Ritron Model(s):	LM-700DMR and RIB-700DMR
Current Firmware Revision:	47.27
Revision Update:	Oct 02, 2025

LM-700DMR and RIB-700DMR Firmware Revision and Update History

R614 vs. V22/V21

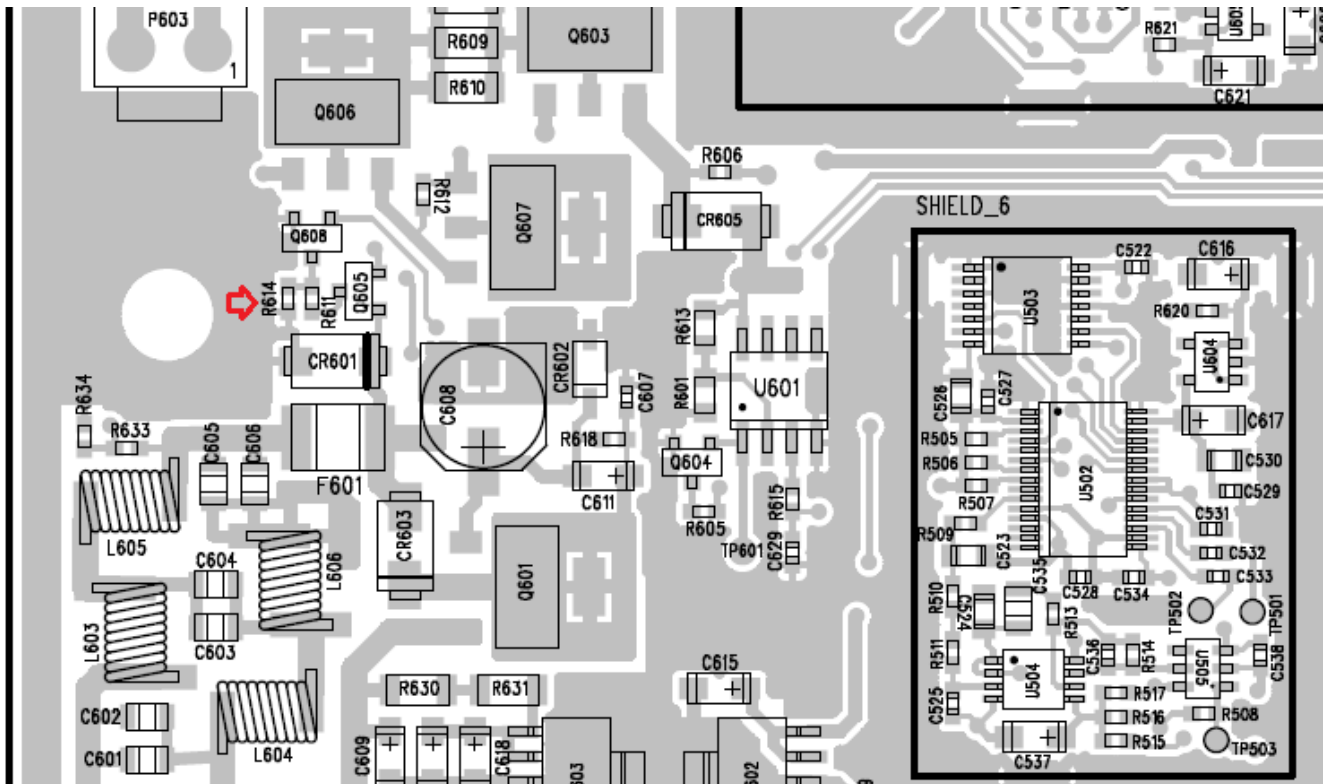
- 1) Added a feature that the unit can auto shutdown when 12V external power is lost and the battery is below 9.5V for at least 5 seconds. Before auto shutdown, the unit will beep 3 times. It is to prevent internal backup battery from over draining. To enable this feature, R614 (0 ohm) has to be removed. R614 was populated on the early units. With V22, if R614 is not removed, the unit will still work like V21, the battery dead auto shutdown just does not work. For the old version firmware, V21 and earlier, if R614 is depopulated, the battery backup function will stop working. i.e. depopulated R614 needs V22 or newer f/w to make the battery backup function work.

R614	Depopulated (new built)	Populated (old built)
F/W V22 and newer	Dead battery auto shutdown (lower than 9.5V) enabled	Dead battery auto shutdown (lower than 9.5V) is disabled, Same as V21 or older

Updated: Added above R614 part locator on Jul 8, 2025.
